DRAWN BY WH 10/27/03	ABS APPV	VESSEL	FRV40 CLASS 63m FISHERIES RESEARCH VESSEL
CHECKED BY AGE 10/29/03	USCG APPV	TITLE	DOCKING DRAWING
APPROVED BY RG 10/30/03	OWNER APPV

DWG NO. M282–085–FA04 SH 1

PLAN 13-C △4 3 △3 1 BLOCK POSITION #1 △1 1 △2 3

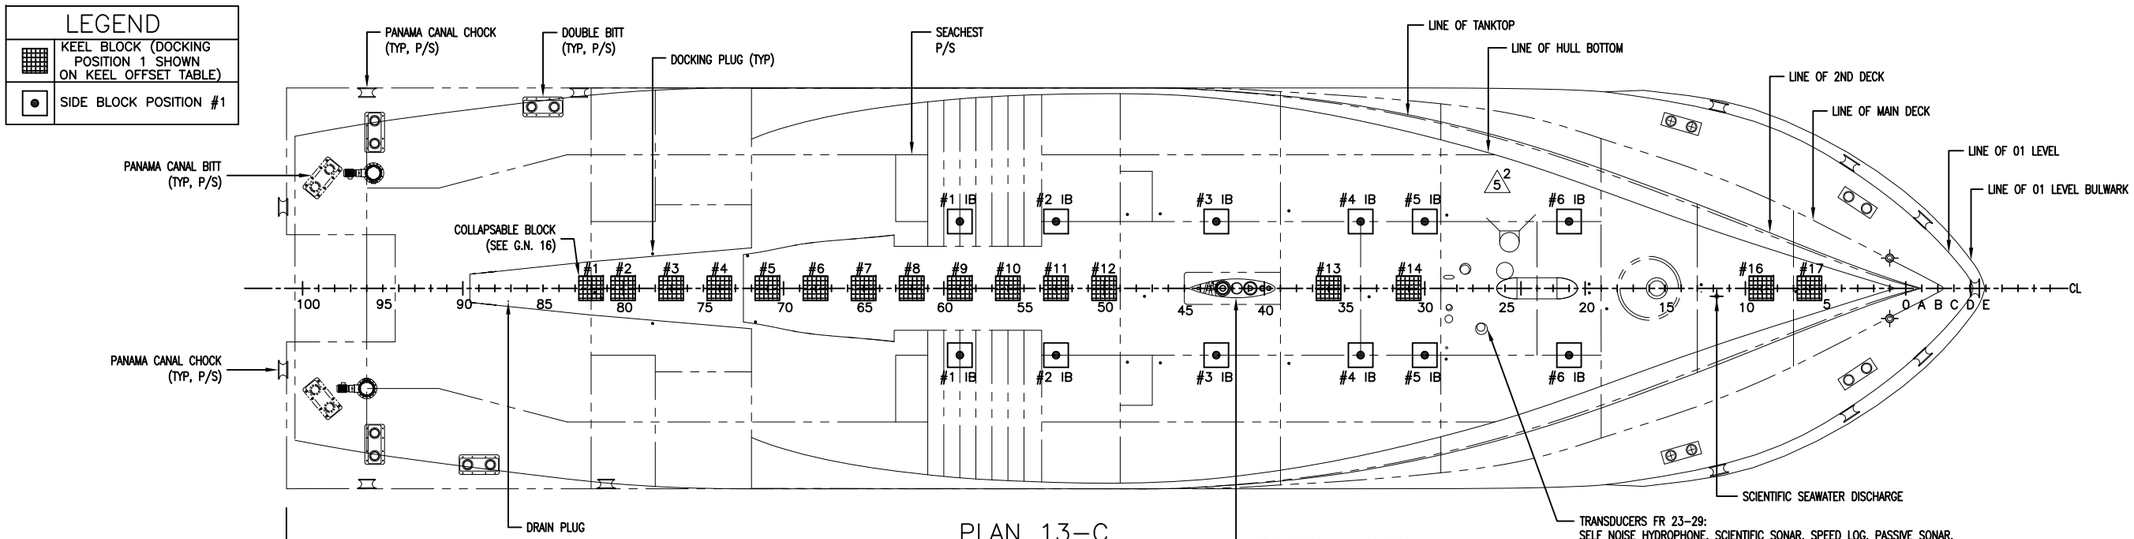
REV	ZONE	DESCRIPTION	DATE	APPROVED
1		1. SH 2, ELEV. 13–A: ADDED TRANSDUCER APPENDAGE AFT OF KEEL BLOCK #15. CORRECTED ELEVATION CALLOUT FROM "13–C" TO "13–A". 2. SH 2, PLAN 13–C: CORRECTED LOCATION AND SHAPE OF TRANSDUCER APPENDAGE. SPLIT KEEL BLOCK #15 TO PORT AND STARBOARD LOCATIONS, 580 OCL, TO CLEAR TRANSDUCER APPENDAGE. CORRECTED PLAN CALLOUT FROM "13–A" TO 13–C". 3. SH 3, PLAN 20–A: CORRECTED LOCATION AND SHAPE OF TRANSDUCER APPENDAGE. REVISED KEEL BLOCK #15 TO MATCH BLOCK POSITION #2. 4. SH 3, PLAN 20–C: CORRECTED LOCATION AND SHAPE OF TRANSDUCER APPENDAGE. 5. SH 6, TABLE FOR KEEL BLOCK NO. 1–17: REVISED BLOCK BEARING PRESSURES FOR BLOCK #15, POSITION 1, FROM 1.755 TO 0.878. REVISED LONGITUDINAL LOCATION AND HEIGHTS FOR BLOCK #15, POSITION 3, TO SUIT RELOCATION TO CLEAR TRANSDUCER. ITEMS 1 – 5 PER ENGINEERING DEVELOPMENT	5/27/04 RMW	5/31/04 RG
2		1. SH 1, GENERAL NOTES: ADDED GENERAL NOTES 15 AND 16. 2. SH 2, ELEVATION 13–A: REVISED LOCATION OF SONAR TRANSDUCER FROM FRAME 25 TO FRAME 23. DELETED KEEL BLOCK #15. 3. SH 2, PLAN 13–C: REVISED LOCATION OF SONAR TRANSDUCER FROM FRAME 25 TO FRAME 23; RENAMED INBOARD BLOCK #3 TO #4 AND ADDED NEW INBOARD BLOCK #3; ADDED NOTE REGARDING OPTIONAL USE OF OUTBD BLOCKS 1–3 P/S. 4. SH 3, PLAN 20–A: REVISED LOCATION OF SONAR TRANSDUCER FROM FRAME 25 TO FRAME 23; RENAMED INBOARD BLOCK #3 TO #4 AND ADDED NEW INBOARD BLOCK #3; ADDED NOTE REGARDING OPTIONAL USE OF OUTBD BLOCKS 1–3 P/S; ADDED REFERENCE TO G.N. 15 TO KEEL BLOCK #1 AND OUTBD BLOCK #1 5. SH 3, PLAN 20–C: REVISED LOCATION OF SONAR TRANSDUCER FROM FRAME 25 TO FRAME 23; RENAMED INBOARD BLOCK #3 TO #4 AND ADDED NEW INBOARD BLOCK #3; ADDED NOTE REGARDING OPTIONAL USE OF OUTBD BLOCKS 1–3 P/S; 6. SH 5, TABLES FOR SIDE BLOCK POSITION 1– 3: REVISED BEARING PRESSURES PER BLOCK TO SUIT KEEL BLOCK 15 DELETION; PROVIDED OPTION TO USE OUTBOARD BLOCKS 1 THRU 3 EXCEPT AS NOTED. 7. SH 6, TABLE FOR KEEL BLOCK 1–17: DELETED KEEL BLOCK 15 FROM TABLE TO CLEAR TRANSDUCER INTERFERENCE; ADDED REFERENCES TO GN 15 AND 16 TO KEEL BLOCK 1; REVISED BEARING PRESSURES PER TO SUIT KEEL BLOCK DELETION. ITEMS 1 – 7 PER M282 REWORK #701–0002	7/15/04 RMW	7/16/04 RG

3		1. SH 2, PLAN 13–C: DELETED ALL OUTBOARD SIDE BLOCKS; RELOCATED INBOARD SIDE BLOCK #3 FROM 27 TO FRAME 30. 2. SH 3, PLAN 20–C: DELETED ALL OUTBOARD SIDE BLOCKS EXCEPT FOR OUTBLOCK #1; RELOCATED INBOARD SIDE BLOCK #3 FROM 23 TO FRAME 27. 3. SH 3, PLAN 20–A: DELETED ALL OUTBOARD SIDE BLOCKS EXCEPT FOR OUTBLOCK #1; ADDED INBOARD SIDE BLOCK #5 AT FRAME 19, 1587 OCL. 4. SH 4, SECTION 20–A: DELETED OUTBOARD SIDE BLOCKS. 5. SH 4, SECTION 23–A: DELETED OUTBOARD SIDE BLOCKS. 6. SH 5, SIDE BLOCK POSITION NO. 1 TABLE: DELETED OUTBOARD BLOCKS 1 THRU 6; CHANGED LOCATION OF INBOARD BLOCK #3; REVISED BEARING PRESSURES TO SUIT NEW BLOCK ARRANGEMENT; CORRECTED BLOCK HEIGHTS; ADDED BLOCK MIDSPAN HEIGHT. 7. SH 5, SIDE BLOCK POSITION NO. 2 TABLE: DELETED OUTBOARD BLOCKS 2 THRU 6; CHANGED LOCATION OF ALL INBOARD BLOCKS; REVISED BEARING PRESSURES TO SUIT NEW BLOCK ARRANGEMENT; CORRECTED BLOCK HEIGHTS; ADDED BLOCK MIDSPAN HEIGHT. 8. SH 5, SIDE BLOCK POSITION NO. 3 TABLE: DELETED OUTBOARD BLOCKS 2 THRU 6; CHANGED LOCATION OF ALL INBOARD BLOCKS; REVISED BEARING PRESSURES TO SUIT NEW BLOCK ARRANGEMENT; CORRECTED BLOCK HEIGHTS; ADDED BLOCK MIDSPAN HEIGHT. 9. SH 6, TABLE FOR KEEL BLOCK: REVISED BEARING PRESSURES TO SUIT NEW BLOCK LAYOUTS. ITEMS 1 – 9 PER M279 TRIAL CARD 1 B 001 OP 01 (M279).	9/23/04 RMW	10/29/04 RMW

4		1. SH 1, DISPLACEMENT PROPERTIES: REVISED DISPLACEMENTS TO SUIT WEIGHT ESTIMATE REPORT #5. 2. SH 1, GENERAL NOTES: REVISED GENERAL NOTE 8 DISPLACEMENT USED IN BLOCK CALCULATIONS FROM 2440.97 MT TO 2613.37 MT TO SUIT INCREASES IN DISPLACEMENT FROM ECP'S. 3. SH 2, PLAN 13–C: RENAMED INBOARD BLOCKS #1 THRU #4 TO #3 THRU #6, RESPECTIVELY. ADDED NEW INBOARD BLOCKS #1 AND 2 AFT OF EXISTING INBOARD BLOCKS. 4. SH 3, PLAN 20–C: RENAMED INBOARD BLOCKS #1 THRU #4 TO #3 THRU #6, RESPECTIVELY. ADDED NEW INBOARD BLOCKS #1 AND 2 AFT OF EXISTING INBOARD BLOCKS. 4. SH 3, PLAN 20–A: RENAMED INBOARD BLOCKS #1 THRU #5 TO #3 THRU #7, RESPECTIVELY. ADDED NEW INBOARD BLOCKS #1 AND 2 AFT OF EXISTING INBOARD BLOCKS. 5. SH 5, SIDE BLOCK TABLES (ALL): REFORMATTED AND REVISED TABLES TO SUIT ADDITION OF NEW INBOARD BLOCKS. 6. SH 6, TABLE FOR KEEL BLOCKS: REVISED BEARING PRESSURE COLUMN TO SUIT BLOCK ADDITIONS. 7. SH 1: EXTENDED HULL APPLICABILITY TO INCLUDE HULL 1956. ITEMS 1 THRU 6 PER ECP 0083. ITEM 7 PER ENGINEERING DEVELOPMENT	4/6/05 AGE	5/3/05 RG
